The information in this section of the reference ABWR DCD, including all subsections, is incorporated by reference with the following departures and site-specific supplements. The site-specific supplements partially address COL License Information Item 16.1.

STD DEP 16.3-8 STD DEP 16.5-1 STD DEP 16.5-2 STD DEP 16.5-3 STD DEP 16.5-4 STD DEP T1 2.14-1 STD DEP T1 3.4-1

ESF Ventilation System
Flowrate

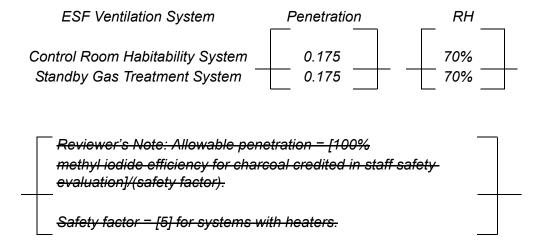
b. Demonstrate for each of the ESF systems that an inplace test of the charcoal adsorber shows a penetration and system bypass < [0.05]% when tested in accordance with Regulatory Guide 1.52, Revision 2, and ASME N510-1989 at the system flowrate specified below [± 10]%:

Control Room Habitability System

Standby Gas Treatment System

6,800 m³/h
